Item Name: Quick Release Basket and Long Cargo Tube Mounting Provisions, Fits LH or RH

DART SERVICE INSTRUCTION

TO AMEND INSTALLATION INSTRUCTIONS D350-607-3 Rev.D,
INSTALLATION INSTRUCTIONS D350-607-4 Rev. C AND
INSTRUCTIONS FOR CONTINUED AIRWORTHINESS ICA-D350-607 REV. 6

REF TCCA STC: SH94-14

FIGURE 1: INSTALLATION OF D4775-041 FWD STRUT

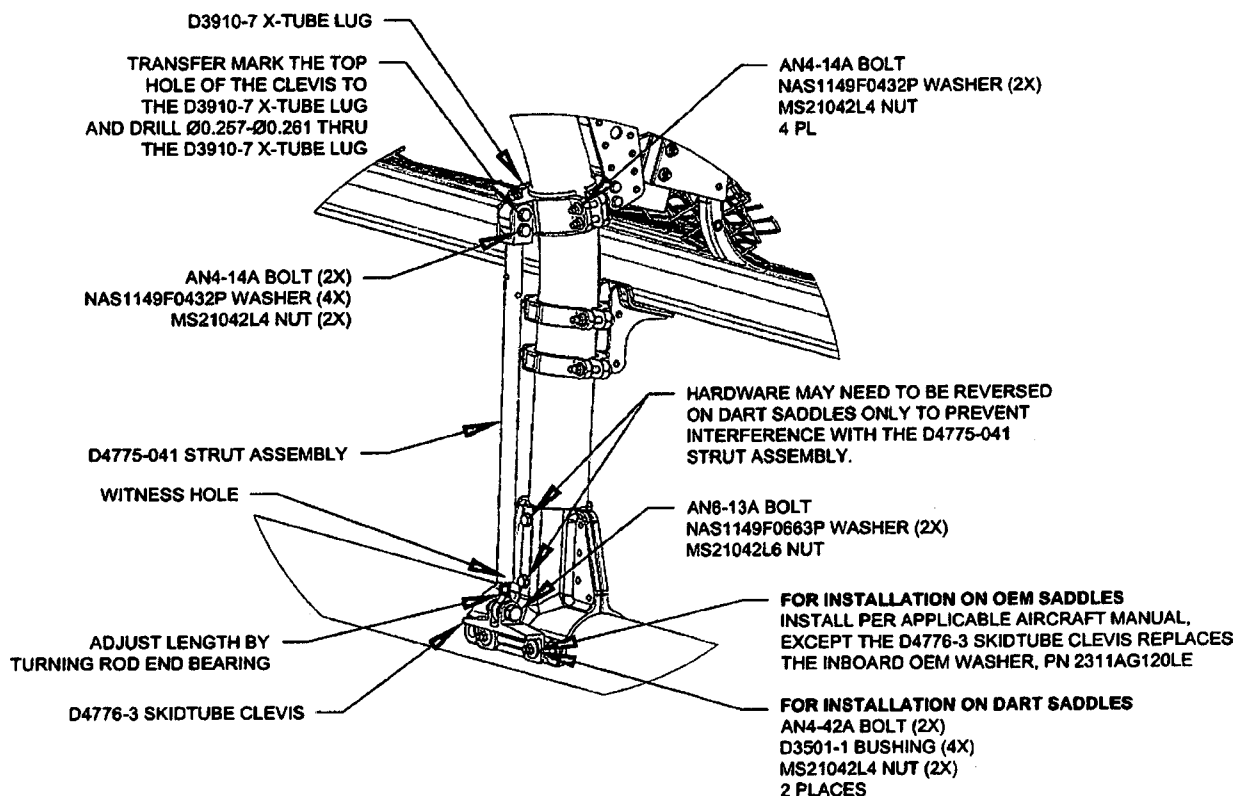
3.1 Substitute the Forward Lower D3910-5 X-Tube Lug with the D3910-7 X-Tube Lug as shown in Figure 1.

3.2 Install the forward D4775-041 Strut Assembly. Transfer mark from the upper hole on the clevis of the D4775-041 Strut Assembly to the D3910-7 X-tube Lug and drill thru the lug $\varnothing 0.257$ - $\varnothing 0.261$ as shown in Figure 1. Touch up chemical conversion coating per MIL-DTL-5541. Check the witness holes located at the bottom end of the D4775-041 Strut Assemblies to ensure that the thread from the rod end extends past the witness hole.
Torque MS21042L4/-4 nuts to 50-70 in-lbs (5.7-7.9 N-m). Torque MS21042L6/-6 nuts to 160-190 in-lbs (18.1-21.5 N-m).
